January 2024 | Danfoss Climate Solutions for cooling

TECH INSIDER

CTM 6 Multi Ejector – Removal of the DST Pressure Transmitter

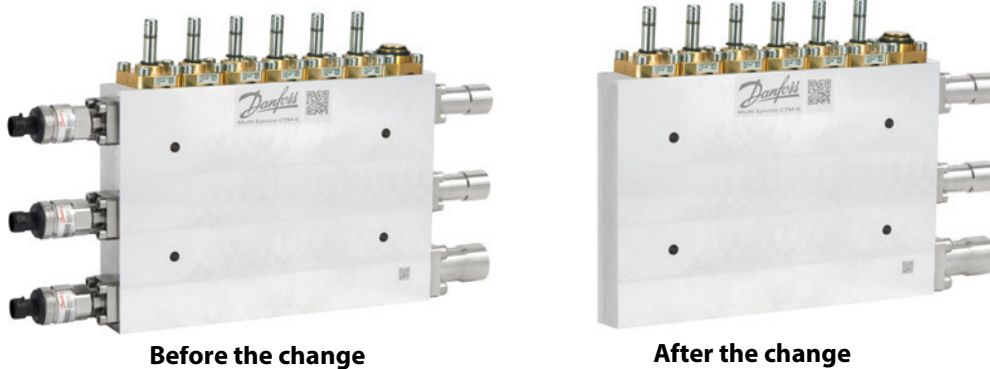
DST P310 pressure transmitters will be removed from CTM 6 Multi Ejectors design.

Danfoss is continuously looking to improve the performance of our products. Recent feedback from our customers show that the pre-installed pressure sensors are almost never used. Therefore, to improve quality and lower our costs, we are removing the pressure sensors from the design.

Pressure transmitter will no longer be part of CTM 6 Multi Ejector design.

An important advantage is less environmental impact – removing difficult to recycle electronic devices and decreasing the weight of the whole product (12 steel screws and sensor mounting plate removed).

Below pictures illustrate the change:
